RFP #845-19P
Bear Park Phase II

Addendum 002
Issued March 21, 2019

Bath Floor Plan

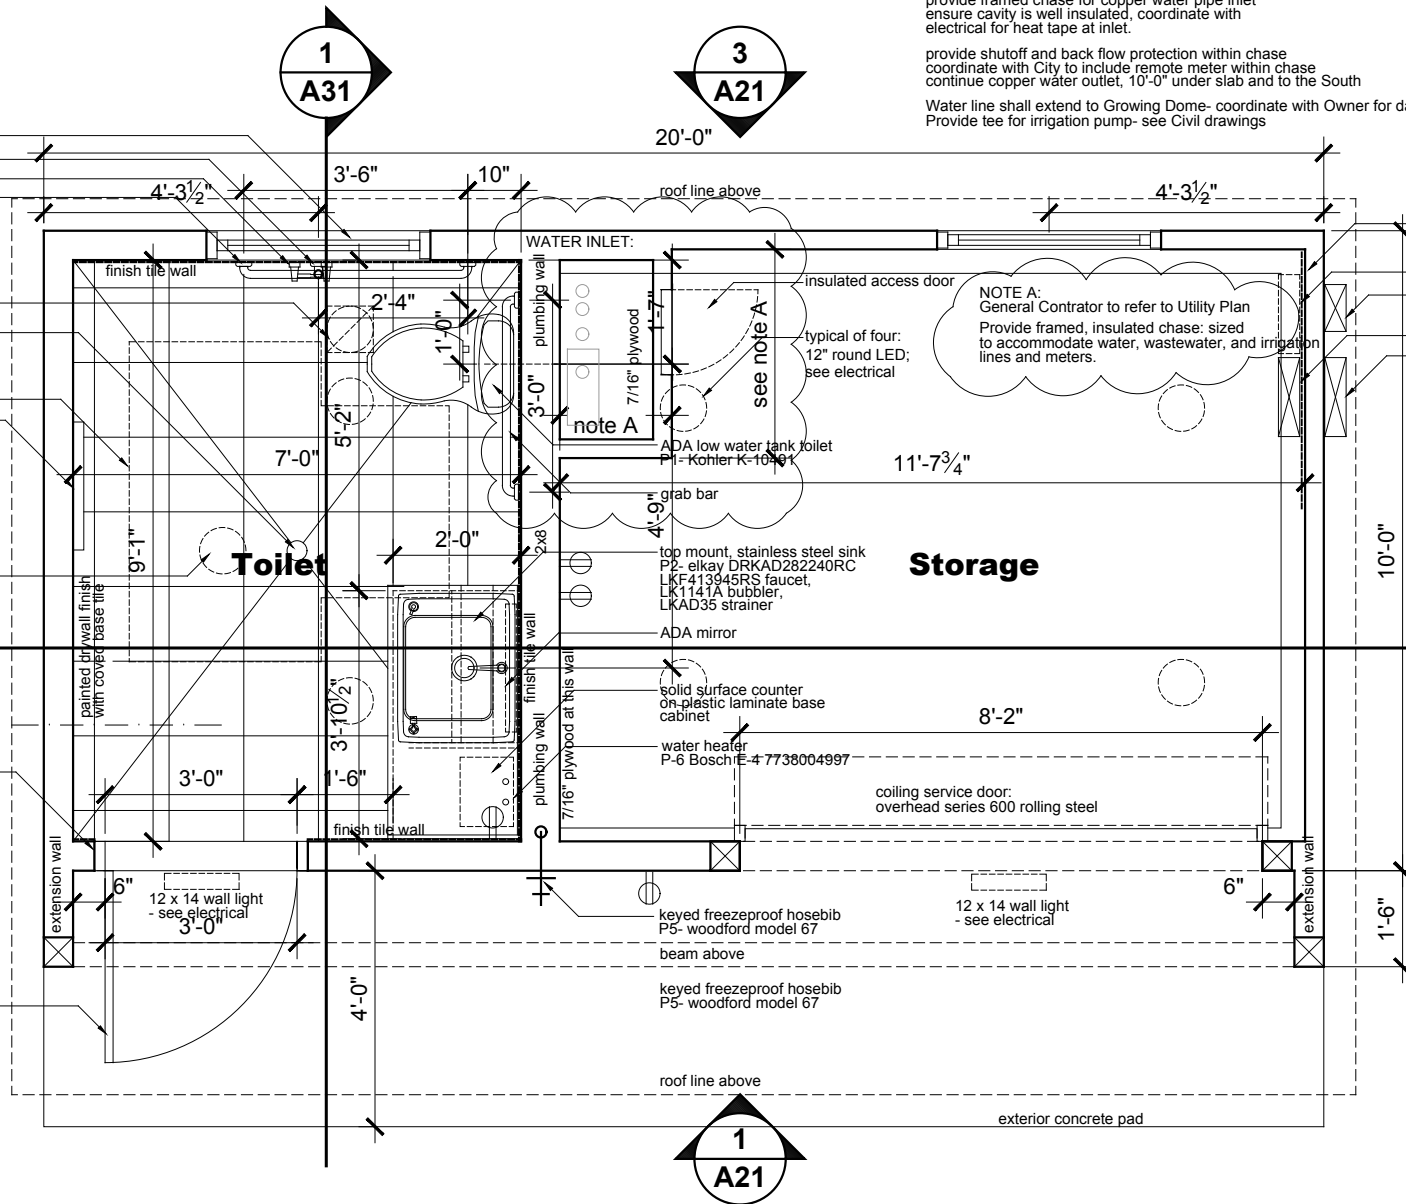
Please see attached revised bathroom plan with revision cloud.

WATER INLET:

provide framed chase for copper water pipe inlet
ensure cavity is well insulated, coordinate with electrical for heat tape at inlet.

provide shutoff and back flow protection within chase
coordinate with City to include remote meter within chase
continue copper water outlet, 10'-0" under slab and to the South

Water line shall extend to Growing Dome- coordinate with Owner for daylight locations
Provide tee for irrigation pump- see Civil drawings

NOTE A:
General Contractor to refer to Utility Plan
Provide framed, insulated chase: sized
to accommodate water, wastewater, and irrigation
lines and meters.
